Gatwick Airport Northern Runway Project

Note on Project-Wide Habitat Loss and Replacement – Tracked Version

VERSION: 2.0

Application Document Ref: 10.45

DRAWING TITLE
 Figure 13
 Loss of Other broadleaved woodland

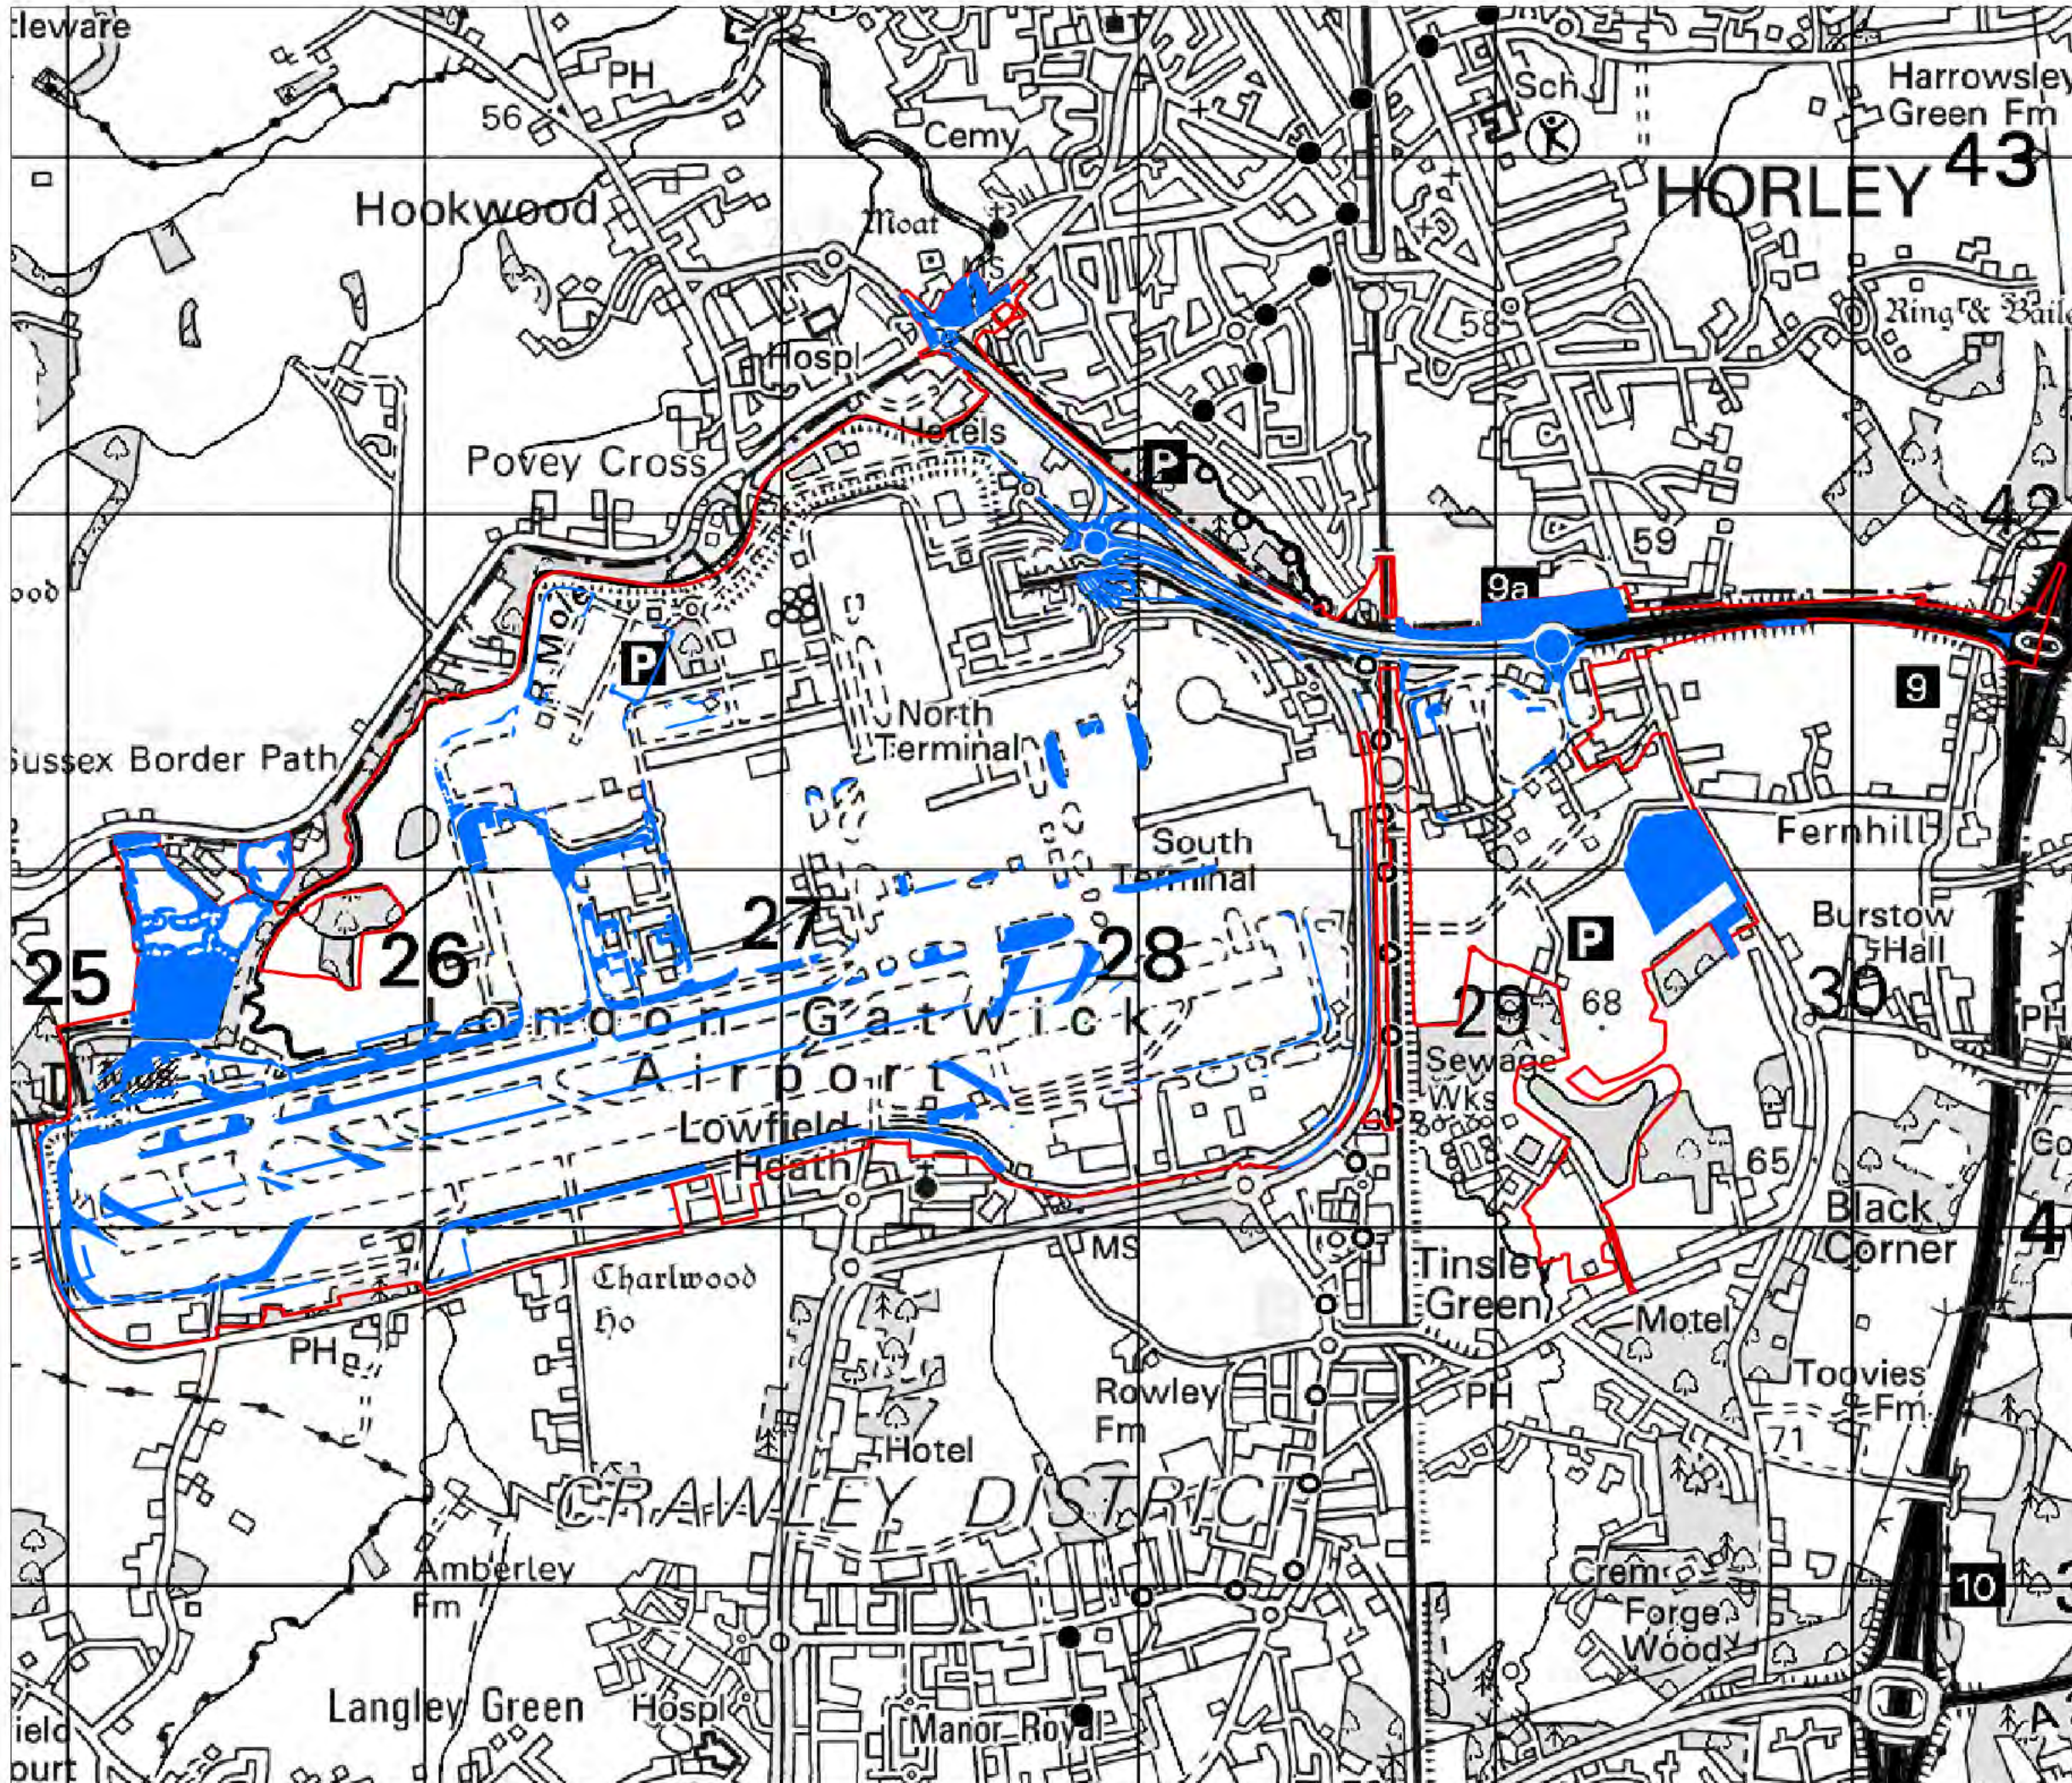
1.1.8 It has also been updated to account for a minor increase in woodland lost (0.2ha) adjacent to the M23 spur that had been previously classified as hardstanding. This anomaly was identified during the amendments to the BNG calculation undertaken to account for Project Change 4.

- 2.2.7 Overall, the loss of habitats primarily comprises:
- woodland (mainly semi-mature highways planting) -~~3.12ha~~[35ha](#)
 - grassland (mainly airfield) -9.84ha
